RESPONSE TO STAFF COMMENTS

TO: Hingham Conservation Commission

RE: 18 Shipyard Drive, Hingham

Please include this Response to Staff Comments with the Notice of Intent (NOI) application under review for the proposed patio project at 18 Shipyard Drive in Hingham (the Site). This submittal responds to the 4/28/26 email with comments as noted below with our response following in italic:

A2.01

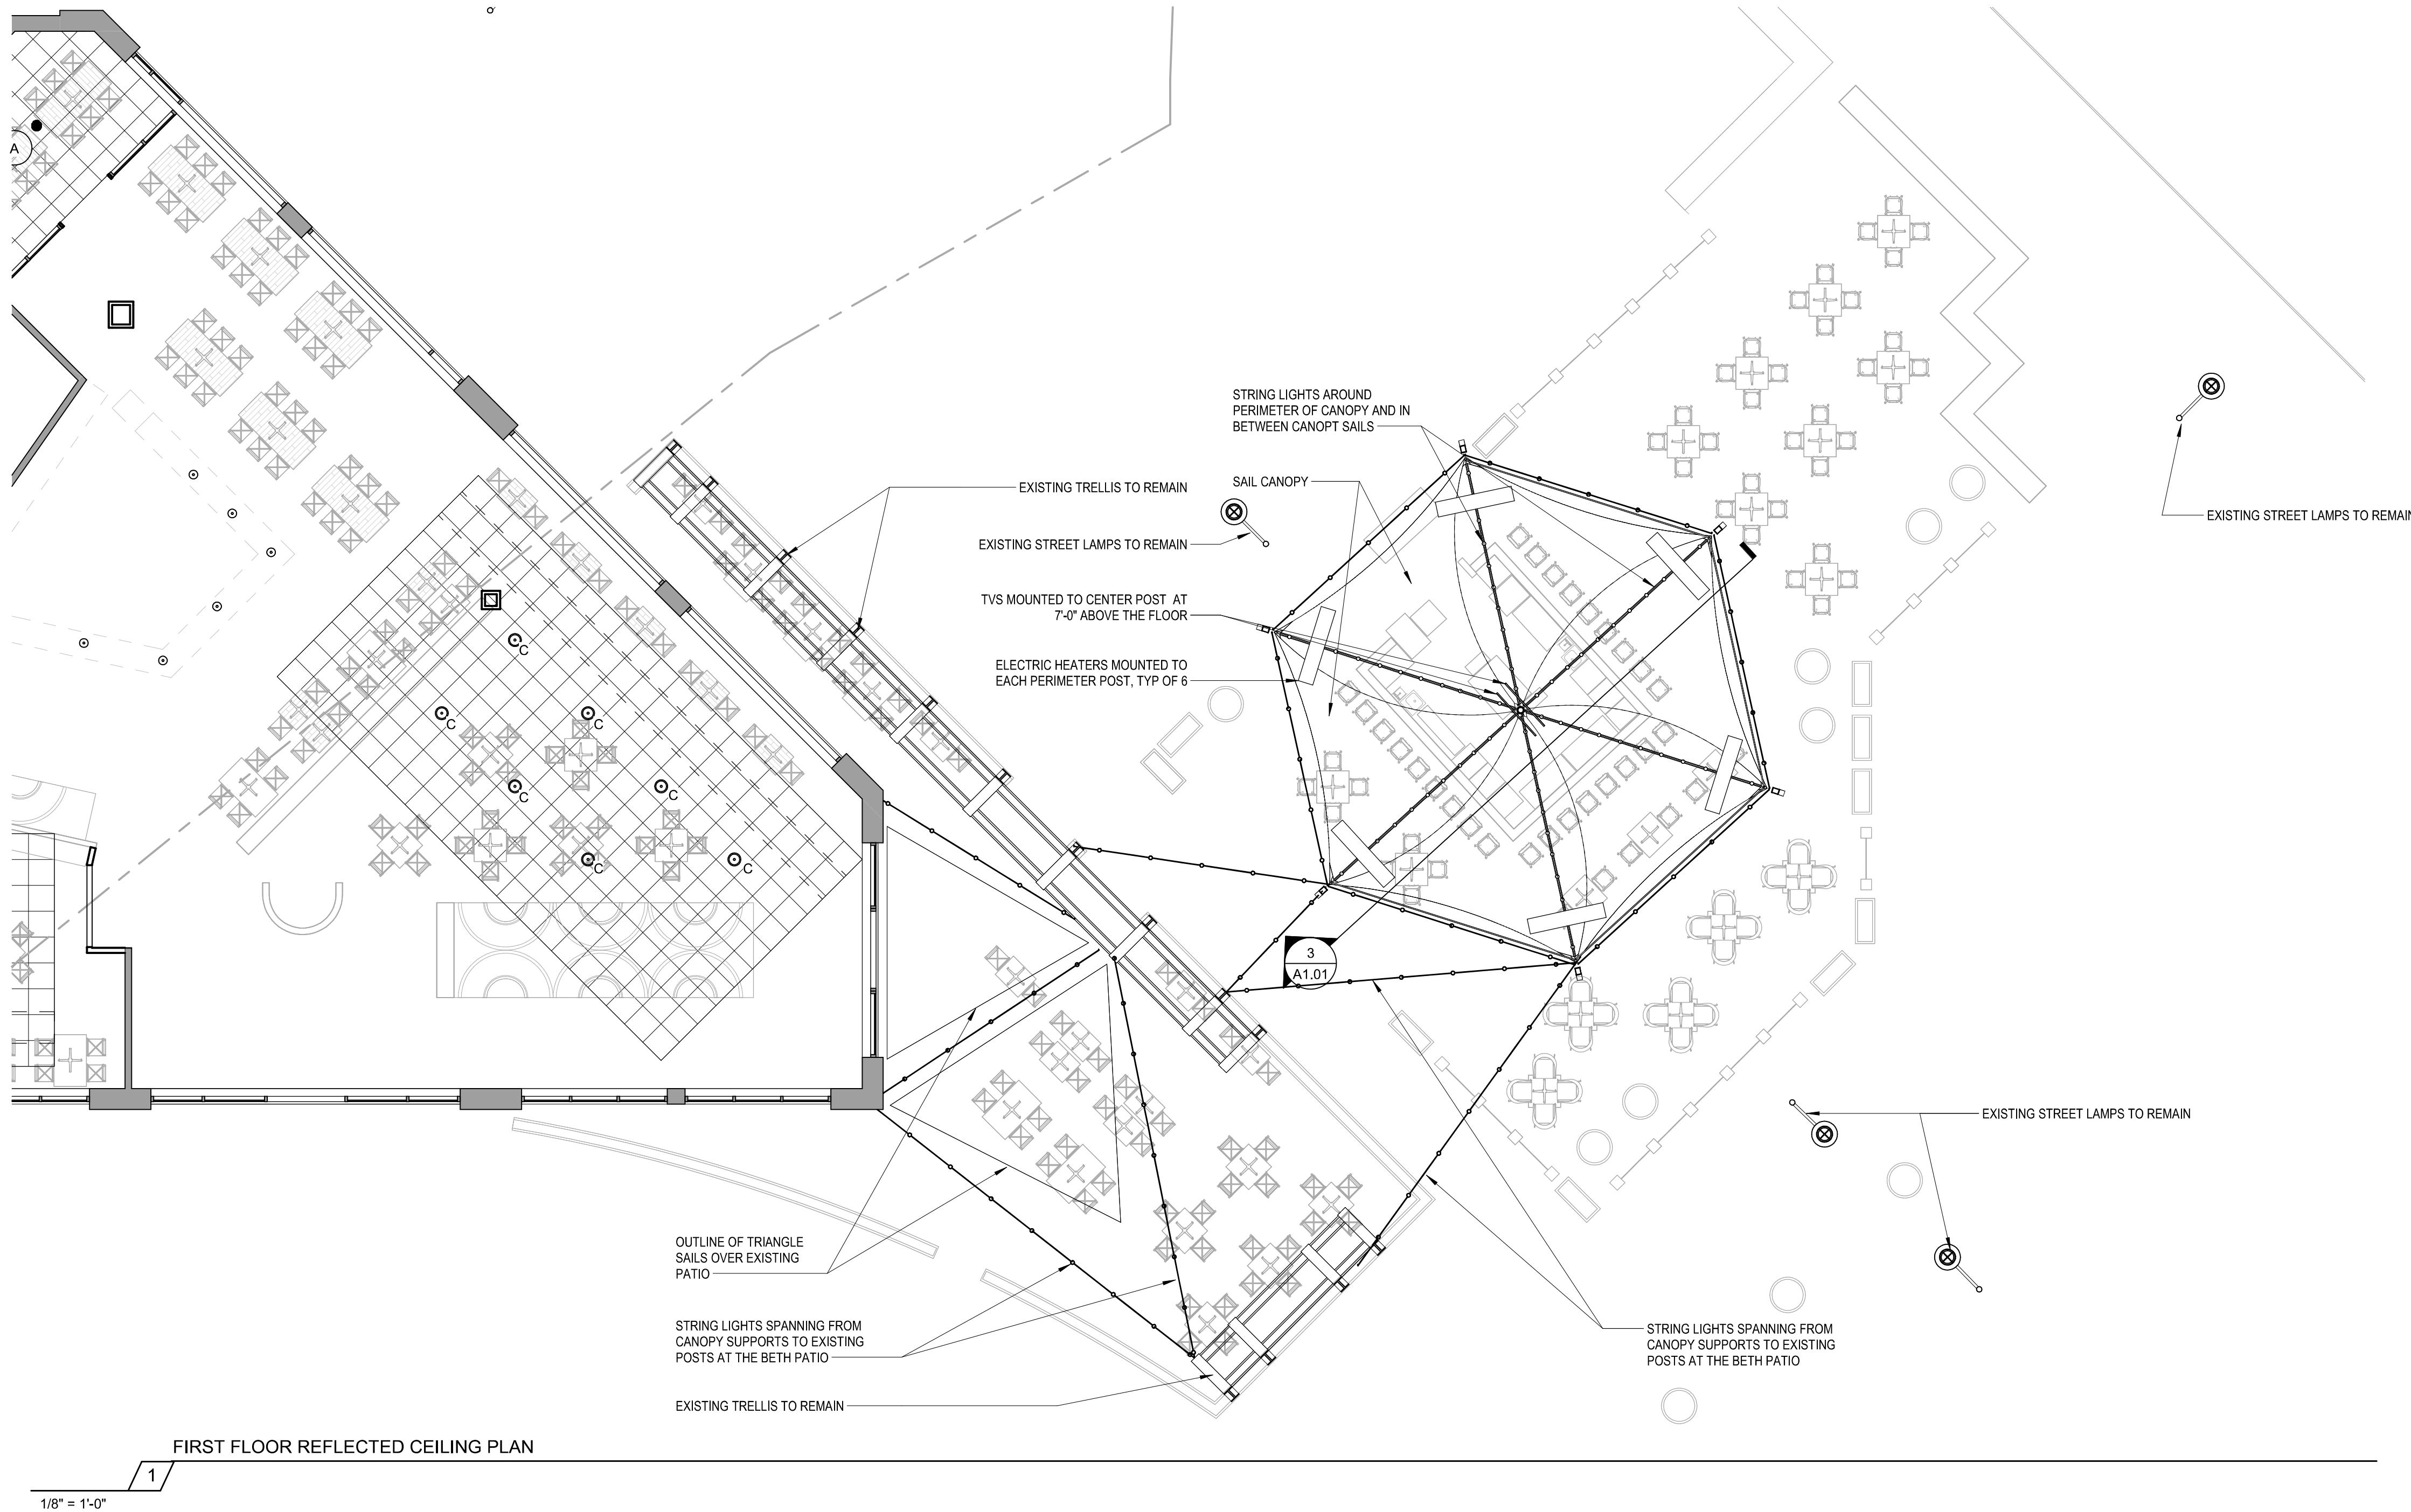
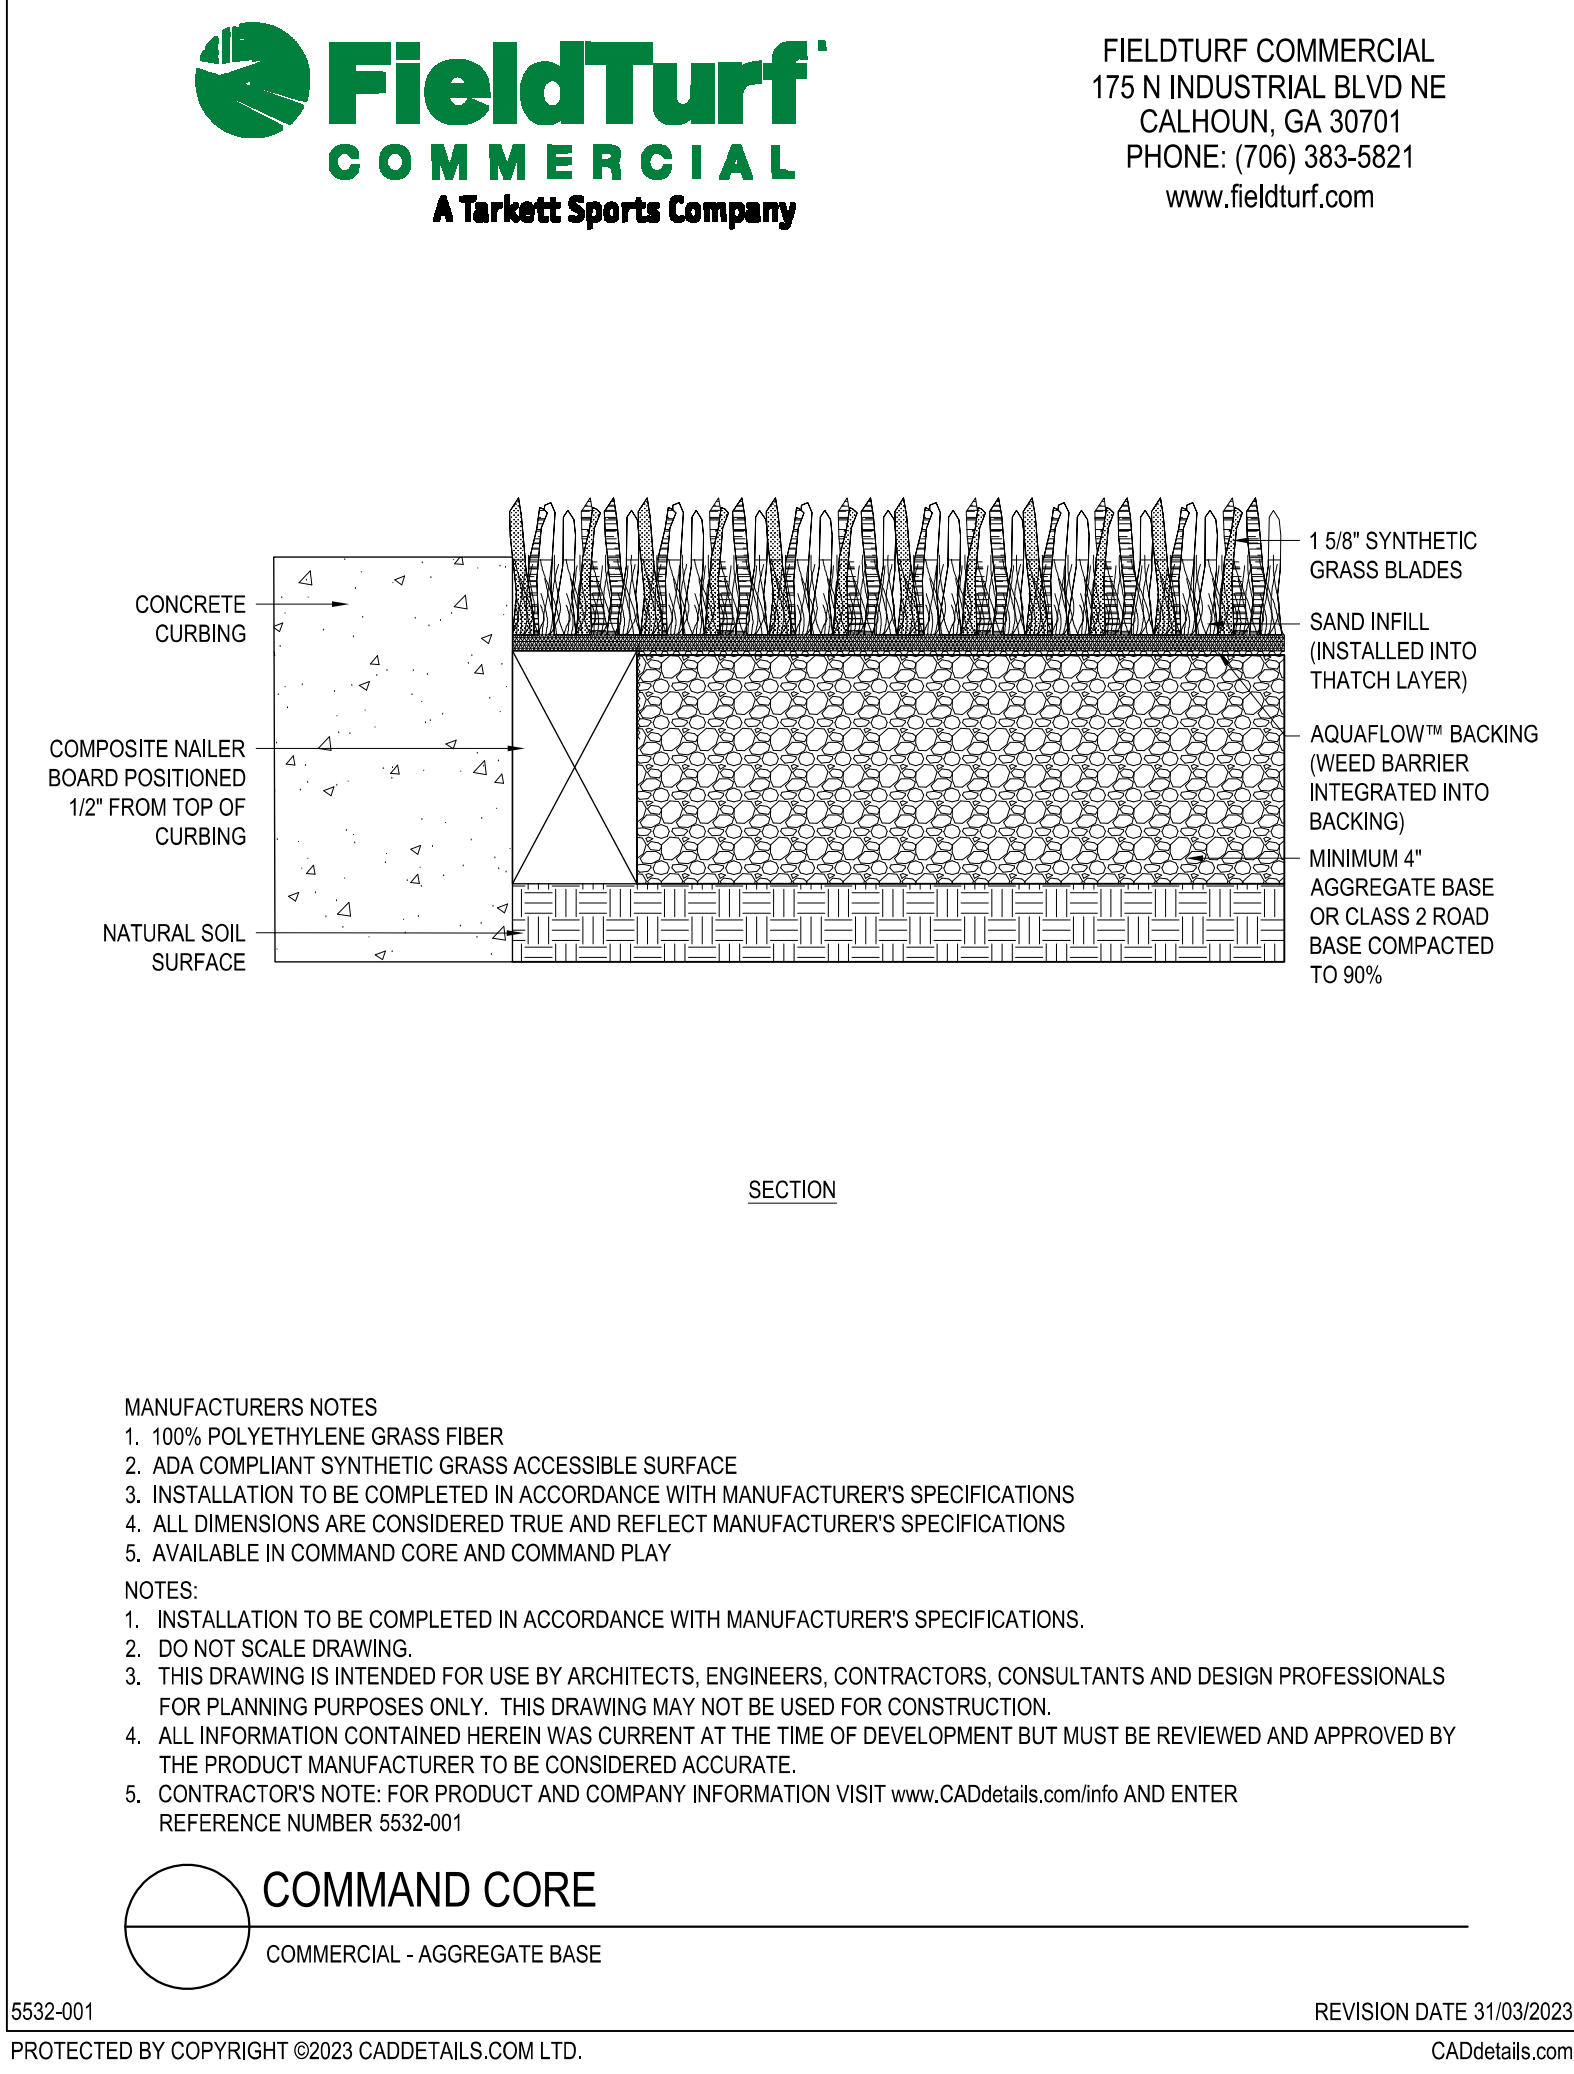
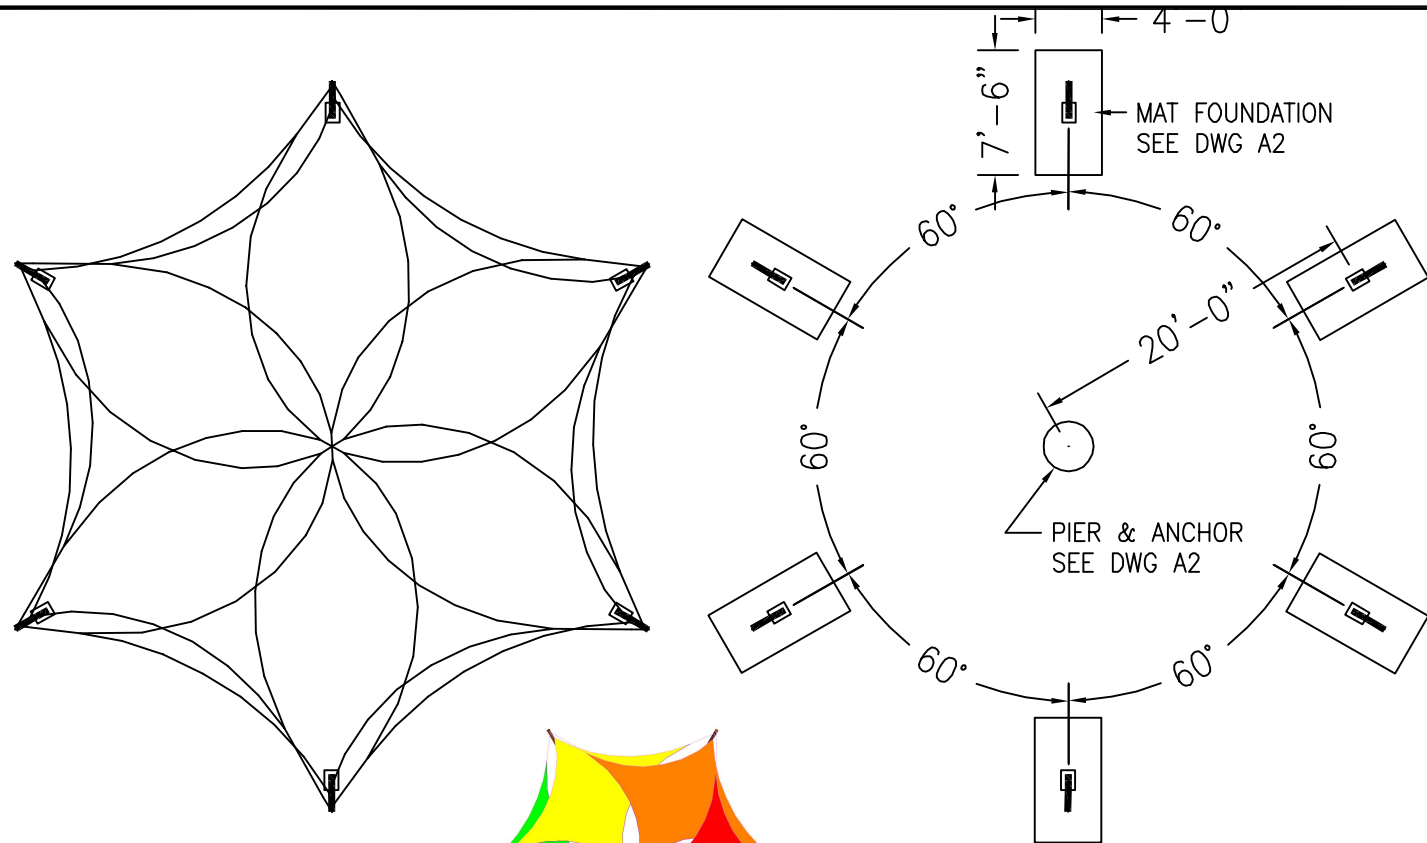
- The project description does not appear to include all aspects of the proposal. Please expand on the proposed pervious patio details and describe any other proposed work in jurisdictional areas

(retaining wall, canopy, bar, etc.) which are apparent on plans uploaded to the town's Permit Eyes (application #65618).

Response –Included in this response submittal are the stamped architectural plans, sheets A1.01 Proposed First Floor Plan, Section and Interior Elevations and A2.01 Reflected Ceiling Plan & Details that include all aspects of the proposed patio project and is what was used as the basis for the exhibit plans submitted as part of this NOI. The NOI Narrative has been updated to reflect the full scope of patio project. Please note that the building permit application #65618 includes outdated plans, which will be corrected to match the stamped architectural plans referenced above.
